Submission for Job: #6010 SSD 6010 - One Residential Building (Student Accommodation) within Darling Drive Plot  
[https://majorprojects.affinitylive.com/?action=view\\_job&id=6010](https://majorprojects.affinitylive.com/?action=view_job&id=6010)

**SSD 6010 - One Residential Building (Student Accommodation) within Darling Drive Plot**

**30 July 2013**

**LEVEL 6**

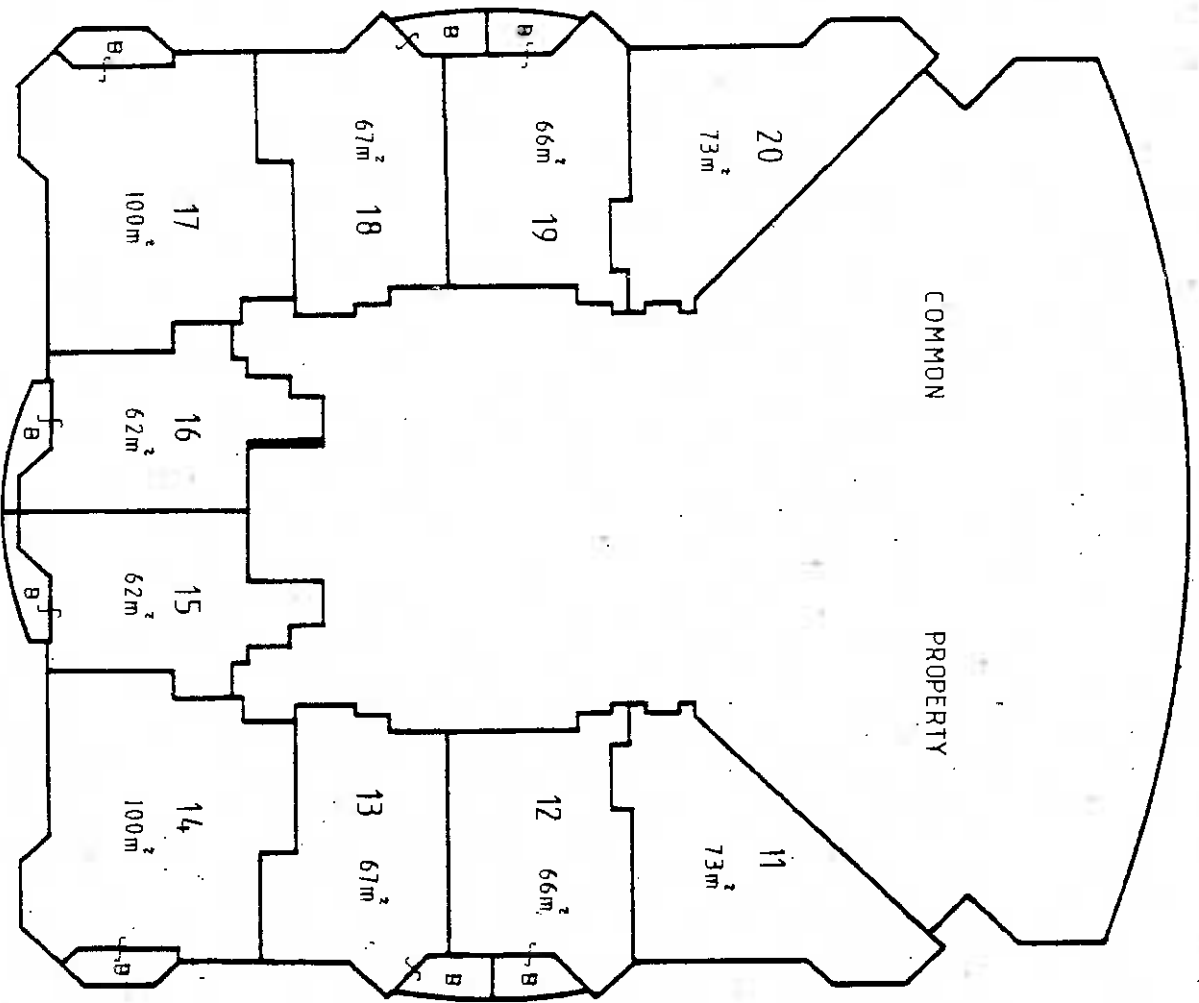
Levels 6 and 7 each contain two apartments with single west aspect , i.e. 4 single aspect apartments.

LEVEL 8

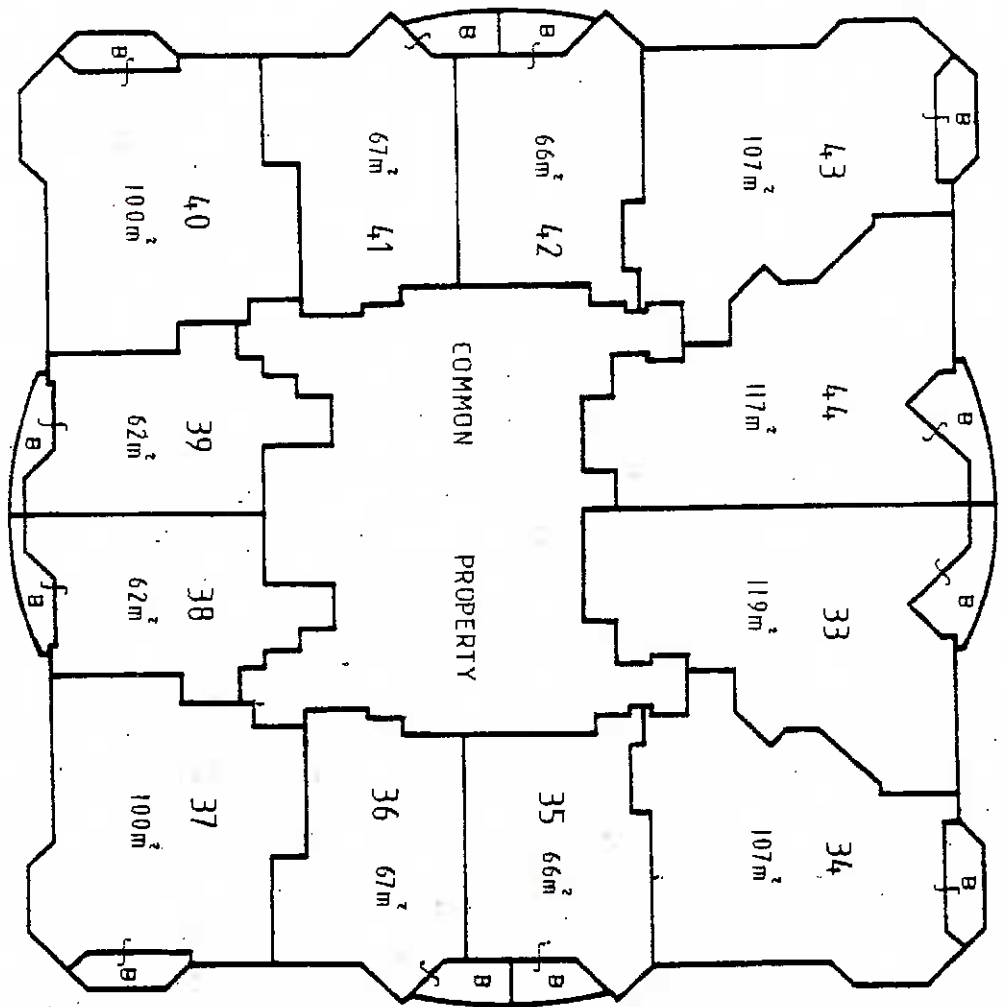
Levels 8-15 each contain two apartments with single west aspect and two apartments with single north aspect , i.e. 4 single aspect apartments per level, giving 32 single aspect apartments.

On levels 8-15, which are lower levels which will experience the most overshadowing, the number of single aspect apartments per level is the highest.
